SPECIFICATION CHANGES ON THE AT-A2150 AND AT-DSP2200

Due to a component change on revision E or higher of the AT-A2150 board and revision F or higher of the AT-DSP2200 board, the specifications listed below have changed. If you have earlier revisions of these boards, you can disregard this note; the specifications in your user manual are correct.

321835A-01 *© Copyright 1997 National Instruments Corp. All rights reserved.* *November 1997*

Figure 1. Input Frequency Response

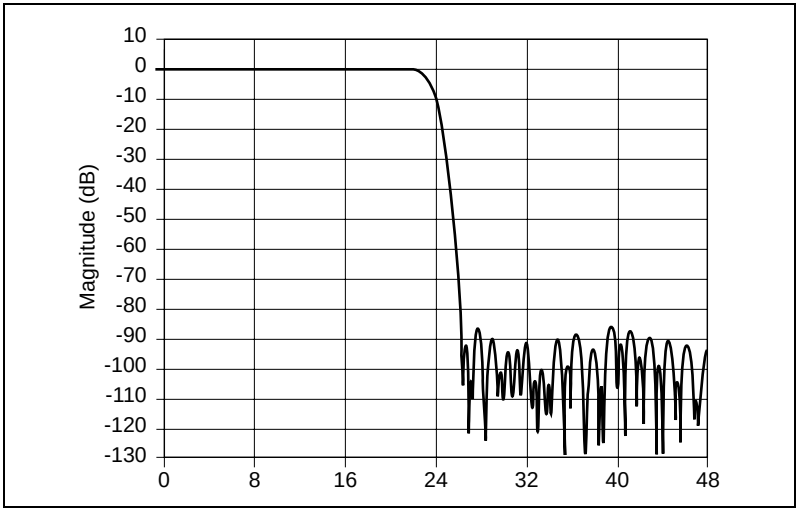
The analog filter cutoff listed on page 3-7 of your user manual has changed from 0.45 times the sample rate to 0.49 times the sample rate. The stopband frequency has changed from 0.5 times the sample rate to 0.542 times the sample rate.

The correct frequency response of the input circuitry is shown in figures 1 and 2. These figures replace figures 3-4 and 3-5 in your user manual.

☞ **Note** ***The response shown in Figure 1 is for a sampling rate of 48 kS/s. For other rates, the x-axis scales proportionally.***
